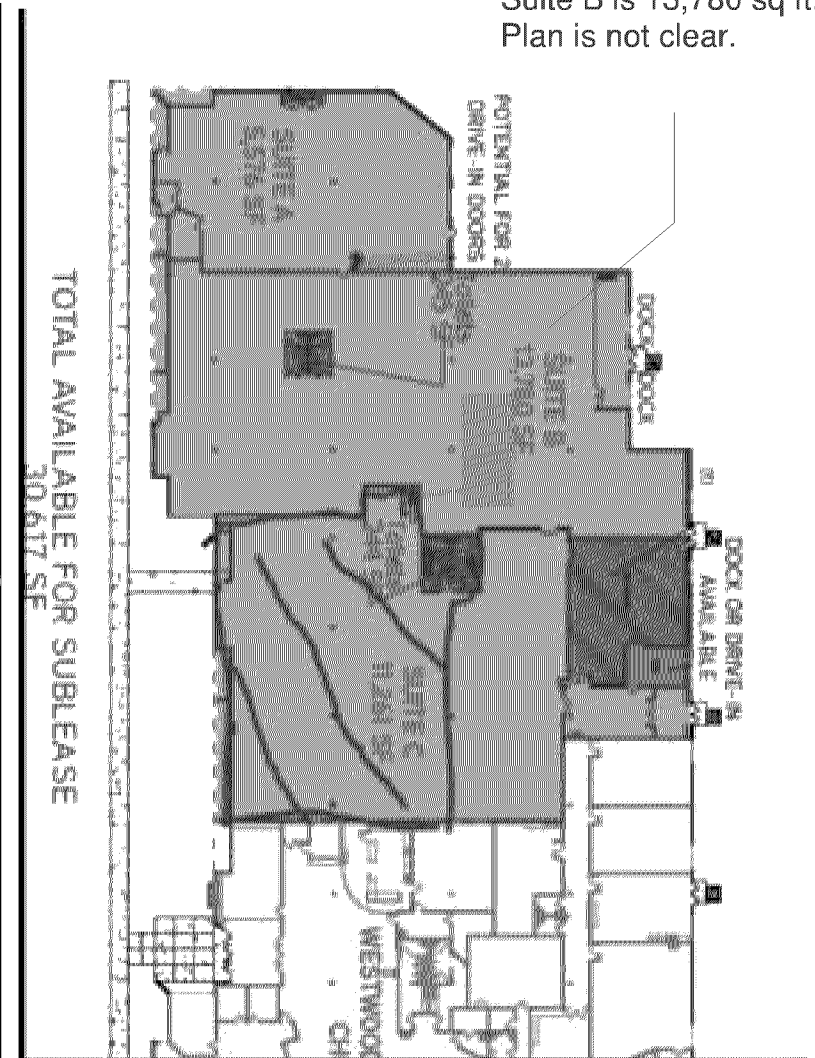
Building plans must be signed by a MN licensed architect.

SAC review by MET council will be required.

According to applicant, Suite B is 13,780 sq ft. Plan is not clear.

Must meet 2020 MN State Building Code

Must meet 2020 MN Accessibility Code

Provide a code analysis with the plans.
